Modification Recommended Service Note

U7179A 16-Channel High Current Load Card up to 15A

Serial Numbers: MY58120772 to MY58121103

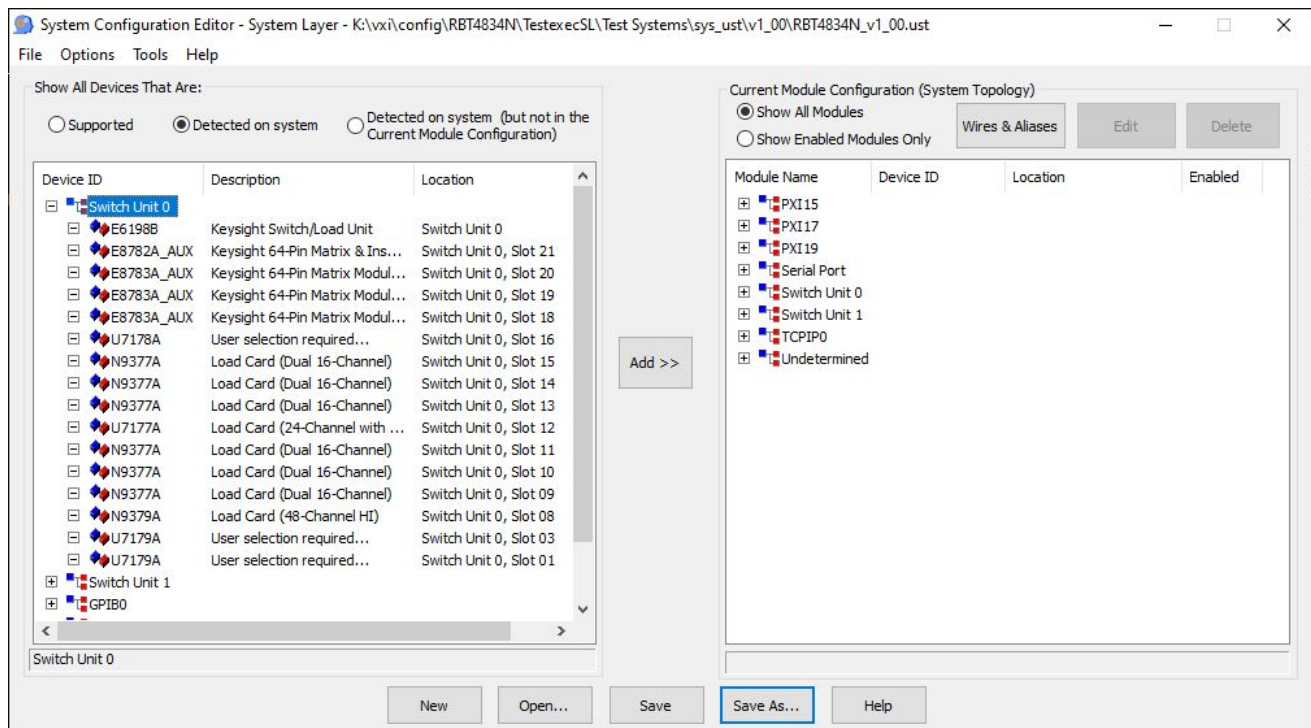
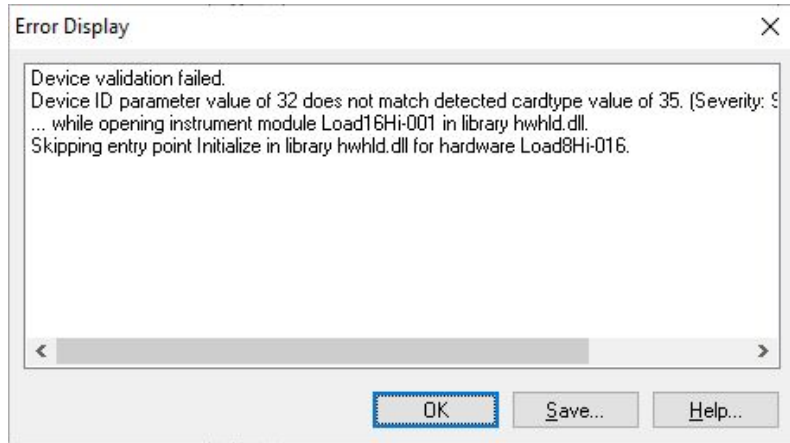
If all load cards are populated in the E6198B SLU (see screenshot), the hardware ID of the U7179A load card in the left-most slot (slots 1 or 3) is not recognized correctly. The correct ID for U7179A card is 32, while the invalid IDs that have been observed could be 33, 35, 36, 37, 38, 39, 40, 41, 44, 46, and 47 (not fixed).

i.e. TestExec gives the following error message when it starts:

Hardware ID detection error only occurred if there are 10 or more cards in the SLU and happened at the left-most slot of the U7179A card. It is determined that delay in control signals that are fed to the ID IC will result in different U7179A ID. This delay causes the time mismatch on the timing diagram thus affecting U7179A ID signals.

When the U7179A load card is identified within the affected serial number range, replace the U7179A load card with U7179-81000. Otherwise, assume that the U7179A load card has no timing issue and do not proceed with this Service Note.
